BIDDING ADDENDUM NO. 06

JOHNSON CITY CENTRAL SCHOOL DISTRICT

JCCSD CAPITAL PROJECT PHASE 2

HA PN 2024-239P

SECTION AT NEW POOL ROOF

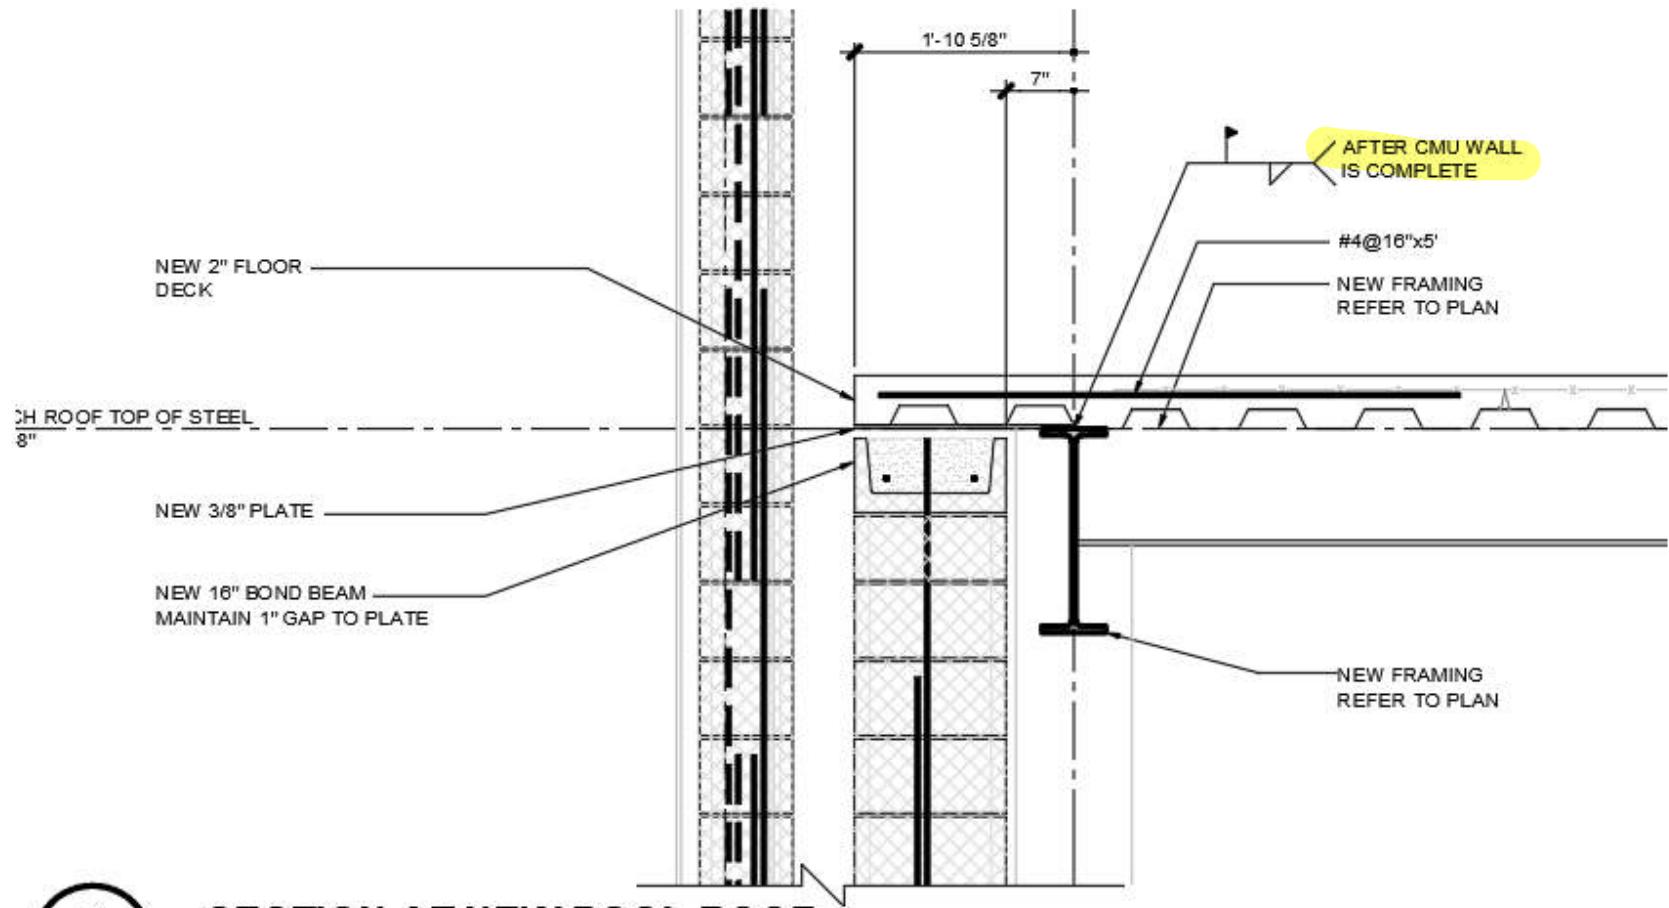
Request: Detail 1/S-508 the new 16" cmu firewall on 4.8 line will not be constructible as shown if the metal plate and decking is installed prior to the cmu wall being completed. Per note om 1/S-504 "this masonry wall shall not be installed until pool deck slab is installed." Can a note be added to ensure the steel plate and decking can not be installed prior to completion of this cmu wall?

NOTE ADDED TO SECTION, SEE REVISED SECTION ATTACHED.

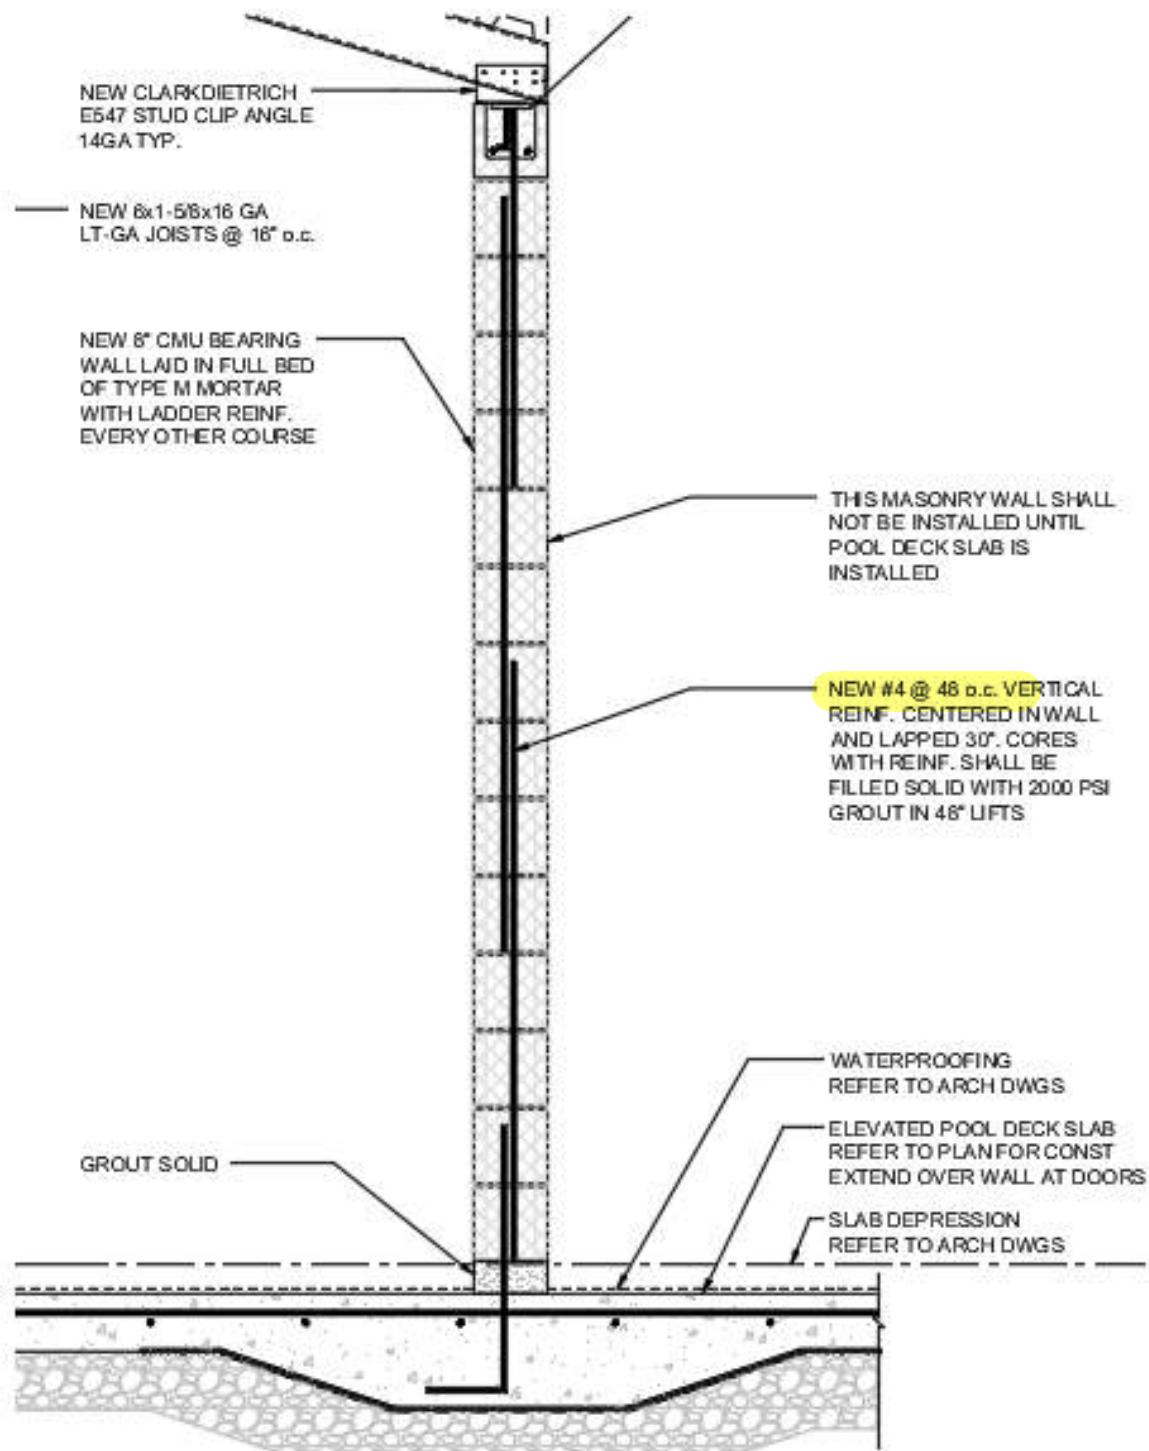
Request: 3/HS S-509 At the pool office cmu bearing wall, please clarify the wall reinforcement size and spacing.

ANSWER: REFER TO ATTACHED

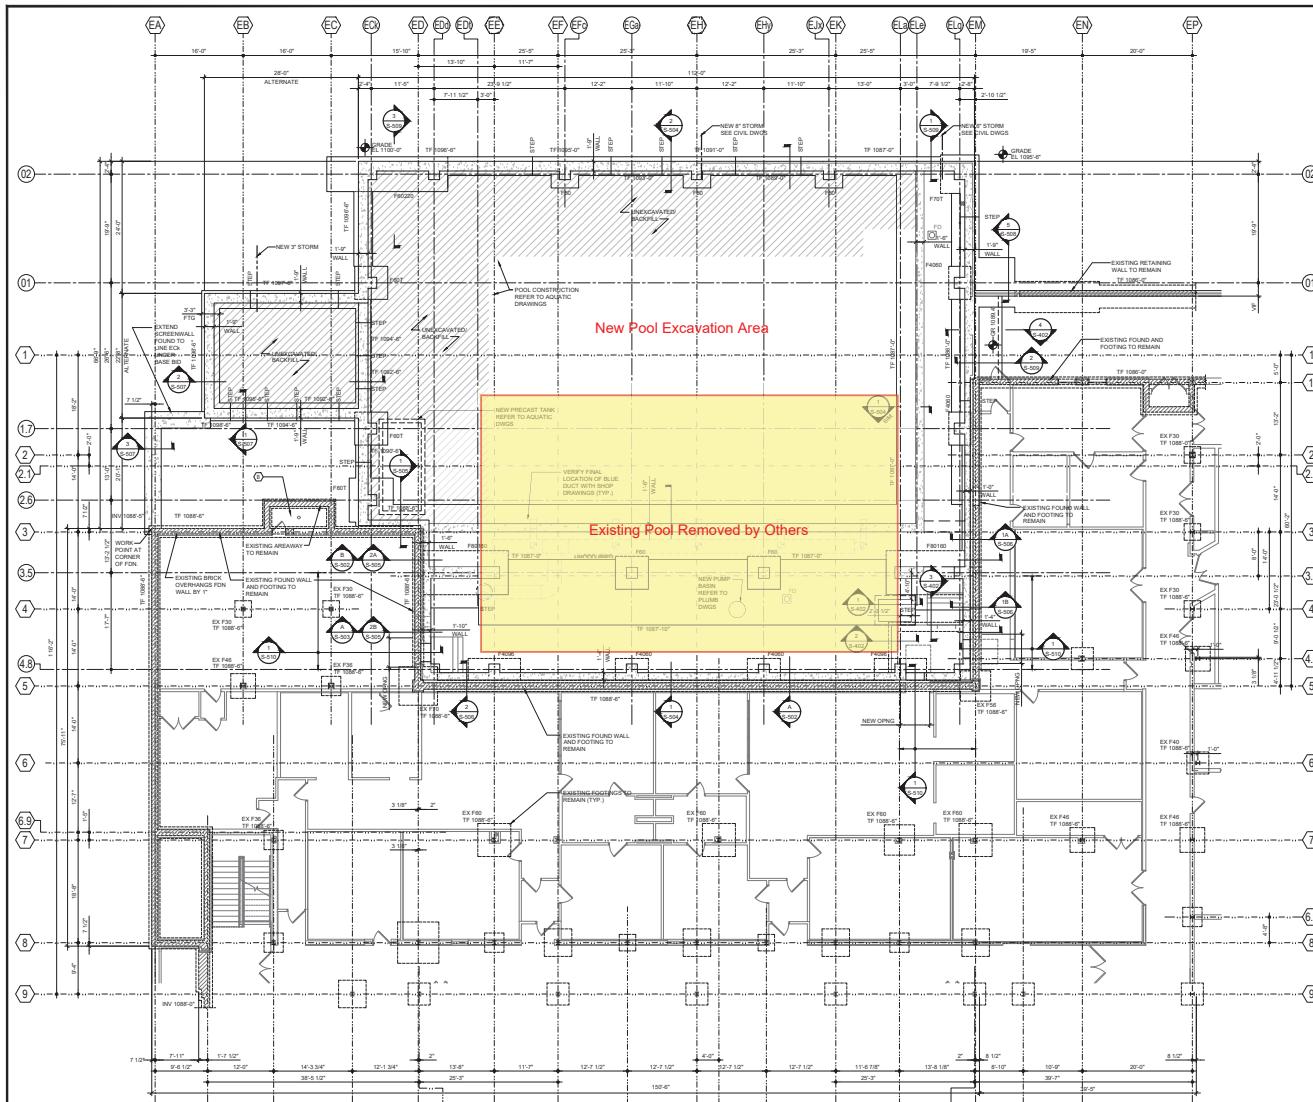
Request: see attached overlay of the existing swimming pool (attached). Who is responsible to backfill the existing pool to subgrade once the pool is removed (area in yellow)?

ANSWER: General Trades is responsible to provide backfill to subgrade for all areas of demolition including the area of the demolished old pool. The Aquatics Contractor is responsible to provide backfill to subgrade at the newly excavated new pool as excavated by the Aquatics Contractor.

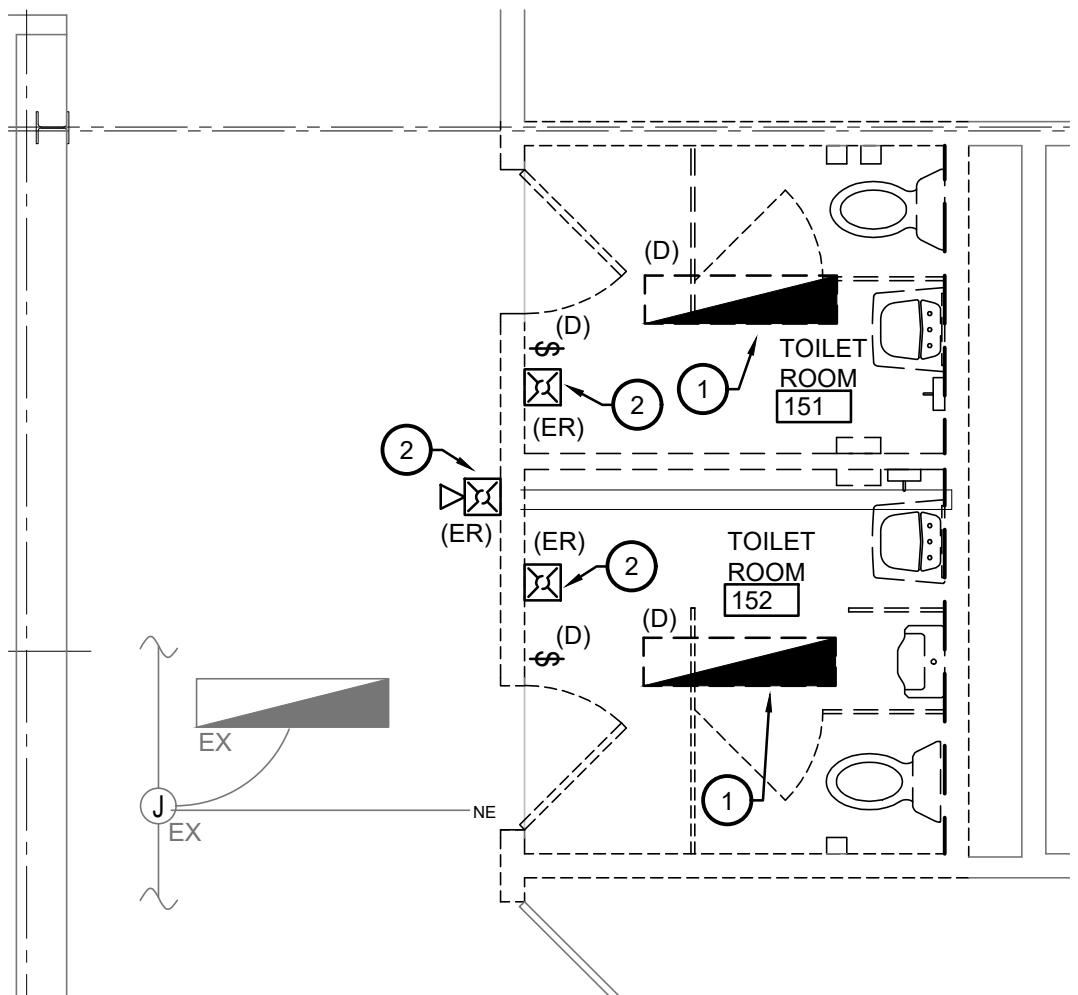
On drawing BG_E102 there 4 door that have access control. Does the wiring go back to the bus garage? If so how far is the bus garage from the south bus storage building?

ANSWER: _____
Refer to BS A-100, per door schedule, access control is hard wired and tied back to new controller to be located in the south bus storage building. Location of controllers shall be determined by Day Automation. All wiring shall be provided by Day Automation. Refer to Drawing HS_E-005A for Day Automation Project Summary with responsibilities, clarifications and exclusions.
